UNITED STATES  
NUCLEAR REGULATORY COMMISSION  
WASHINGTON, D.C. 20555-0001

SUBJECT: POINT BEACH NUCLEAR PLANT, UNITS 1 AND 2– STAFF  
ASSESSMENT OF RESPONSE TO 10 CFR 50.54(f) INFORMATION  
REQUEST – FLOOD-CAUSING MECHANISM REEVALUATION  
(CAC NOS. MF6100 AND MF6101)

STAFF ASSESSMENT BY THE OFFICE OF NUCLEAR REACTOR REGULATION

POINT BEACH NUCLEAR PLANT, UNITS 1 AND 2

**Figure 3.2-3. Location of Temporary Wave Barriers as Described for Scenario B**

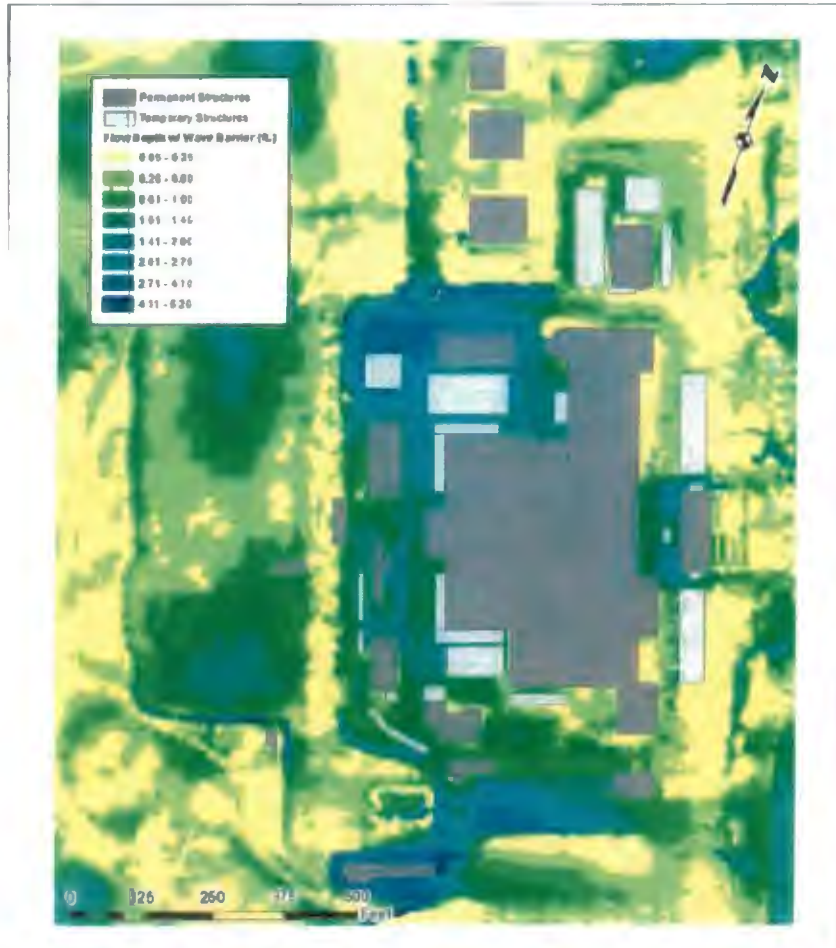
The licensee considered two scenarios for the LIP flooding analysis. Scenario A considers the temporary laydown areas completely occupied with equipment/containers. Scenario B is similar to Scenario A, but with additional temporary wave barriers installed adjacent to the CWPH. When the water level of Lake Michigan exceeds an administratively controlled limit, temporary wave barriers will be installed at the Point Beach site along the roll up doors on the north and south side of the CWPH, as shown on Figure 3.2-3 of this assessment. The licensee created Scenario B to assess the impact of these wave barriers, also referred to as door barriers. The plan for the installation of barriers was updated following a 2014 walkdown, and six barriers of 8 feet (ft) by 25 ft with a height of 3.5 ft were represented in the model as a wider structure of 15 ft by 25 ft (NextEra, 2015a).

In the FHRR, it is stated that during high lake level conditions, 3.5 ft high wave barriers are installed outside the CWPH rollup doors and sandbags are placed to seal the rollup doors. When the barriers are installed, the maximum LIP flood heights near the CWPH doors are projected to increase to 3.4 ft. The licensee stated during the audit (NRC, 2016) that the 100-year high lake level of 1.8 ft-Plant Datum for Lake Michigan was not used in the FLO-2D runoff model since site grade and associated features are at least 3 ft higher than the high lake level.
